**General Bid Bulletin No. 5**  
06 September 2021

**METRO MANILA SUBWAY PROJECT PHASE I**

**PACKAGE CP103:**  
**TWO UNDERGROUND STATIONS (ANONAS AND KATIPUNAN)**  
**AND TUNNELS**  
**(IFB No: 21-035-6)**

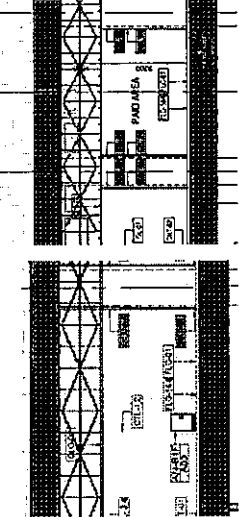
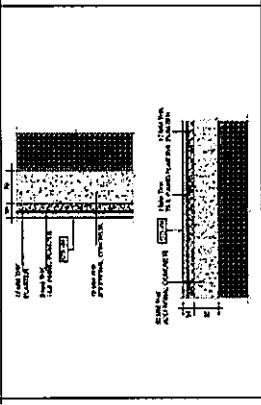
26.	(WR)_4(TS_MEP)_1Mar2021 -6: Tunnel Lighting Tunnel Lighting system	Tunnel Lighting system Center of tunnel, Anonas st East Ave st Anonas st to Katipunan st Center of tunnel, Katipunan st to Ortigas st Considering tunnel lighting area, Please confirm.	Refer to the Employers drawing. Demarcation lines for all MEP works are basically the same even if it shows one service or system upon the other. Therefore, this connotes that the demarcation line as well shown here can be applied for tunnel lighting

<b>Metro Manila Subway Project Phase 1 PACKAGE CP103 (Aonias and Katipunan)</b>		
ITEM NO.	REFERENCE/CLAUSE/SECTION	RESPONSE
	QUERIES	
		system, however, any doubt can be raised further for the designer's response as this issue(s) is their main scope. (Please refer to Ref Dwg No's STN-MEP-FPS-TUN6-2101 and STN-MEP-FPS-TUN7-210)
